**SUBJECT: US Army Concern re Safety of Cielo Ranch (Gombert Tract subdivision)  
Intersection at FM 3351**

Transportation & Capital Improvements Department (TCI)  
Traffic Plan Review Section  
Traffic Impact Analysis  
**REQUEST FOR REVIEW**

**Project Name:** Gombert Tract Residential Development

**TIA ID. #:** TIA20170806

1. Map of CSSA Gates
2. Map Excerpt from Driveway permit
3. TCI 2017 Request for Review

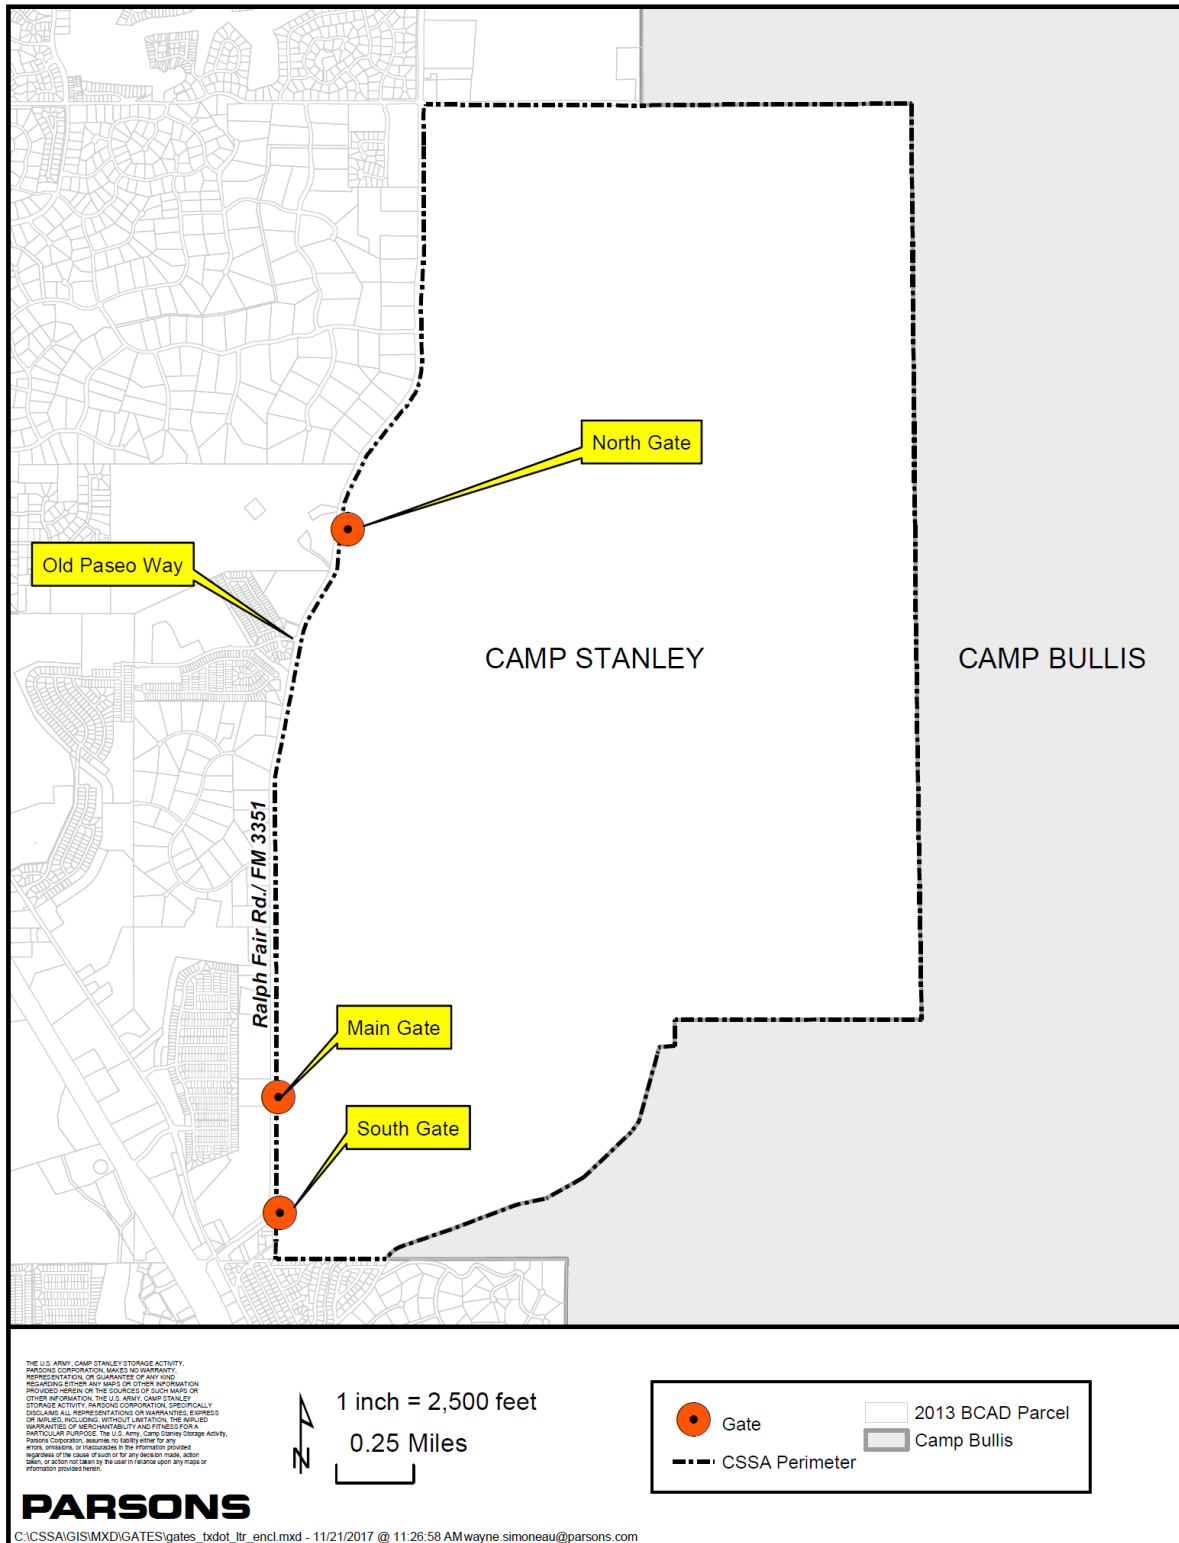
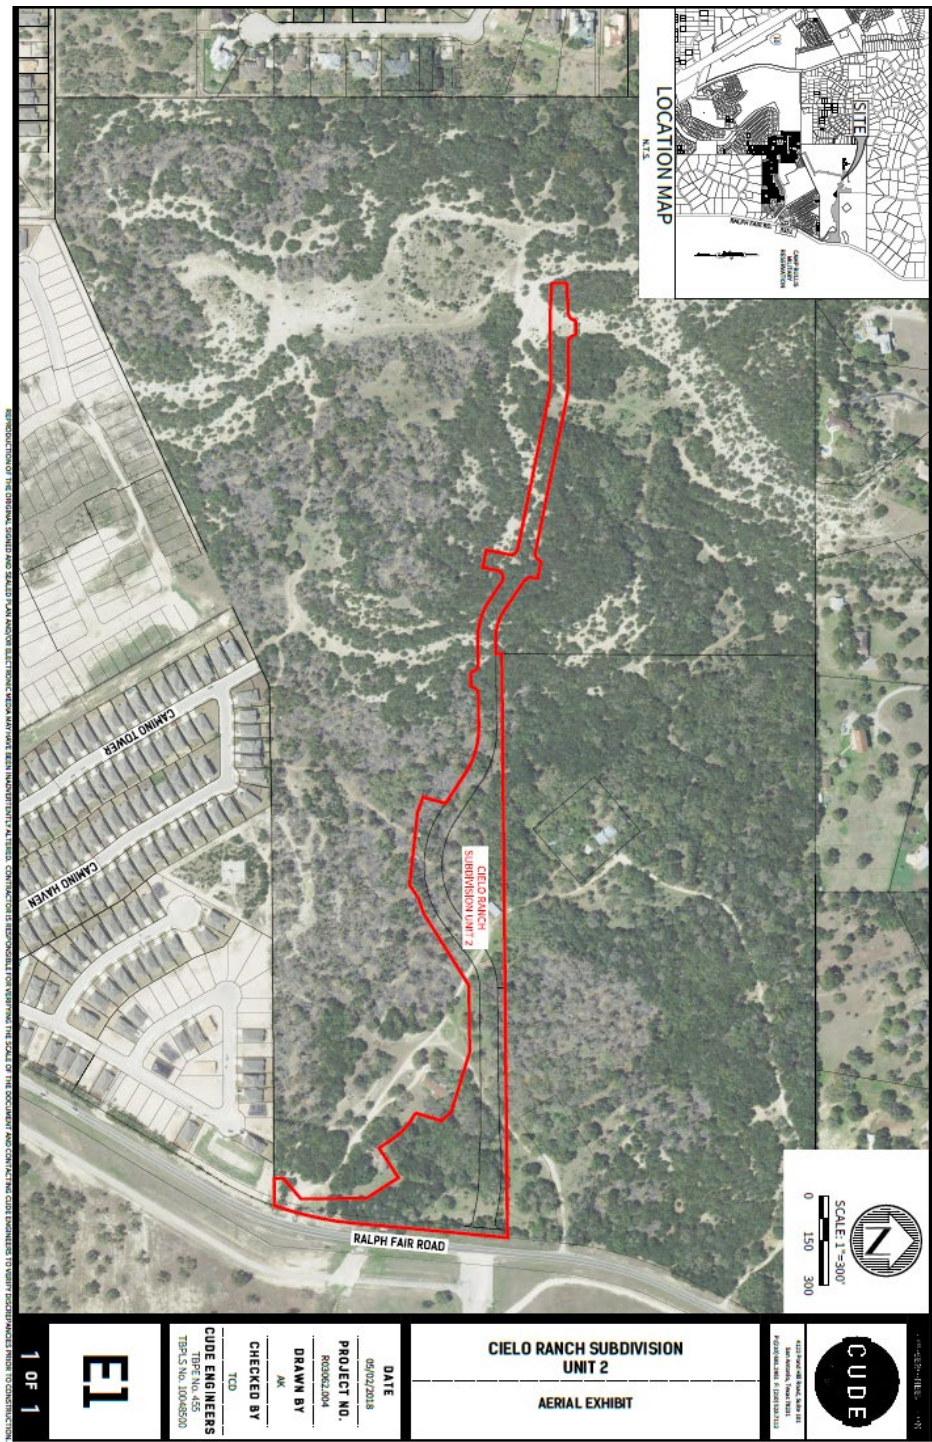
On behalf of the US Army at Camp Stanley, I am submitting a comment regarding the 518-lot Cielo Ranch housing development's access point to FM 3351/Ralph Fair Rd. Their proposed primary driveway and turn-in lane area is directly across from our only munitions truck ingress and egress gate (gate 5). The Army has a significant concern over safety unless this access is controlled by a traffic light, and this should be done early on in the development phasing.

Having up to 1,000 vehicles exiting directly across from our only munitions/cargo gate at an uncontrolled intersection raises significant safety concerns. These trucks can carry large quantities of explosives (up to UN Hazard Class 1.1) and one accident would be one too many. Although the materials are packaged IAW Department of Transportation standards for safe transit, in the event of a fire, the resulting explosion could be catastrophic. We have never had an accident involving one of our ammunition trucks and would like to keep it that way. In addition to Camp Stanley's munitions, we are also a DoD area Safe Haven for munitions trucks transiting IH-10 which need a safe/secure area to park overnight. In a typical month we average 81 semi-trucks carrying ammunition/cargo use our gate with our heaviest month totaling 146 trucks.

See enclosed Aug 14, 2017 TCI review letter of this project, which we received a copy of last week from TXDOT. The 2<sup>nd</sup> page notes a traffic signal should be installed by the developer. From a meeting with Cude Engineering and TXDOT yesterday, we understand the developer plans on delaying this for several years later in the phasing. This delay is not acceptable given the safety issues that this new flow of oncoming traffic would present.
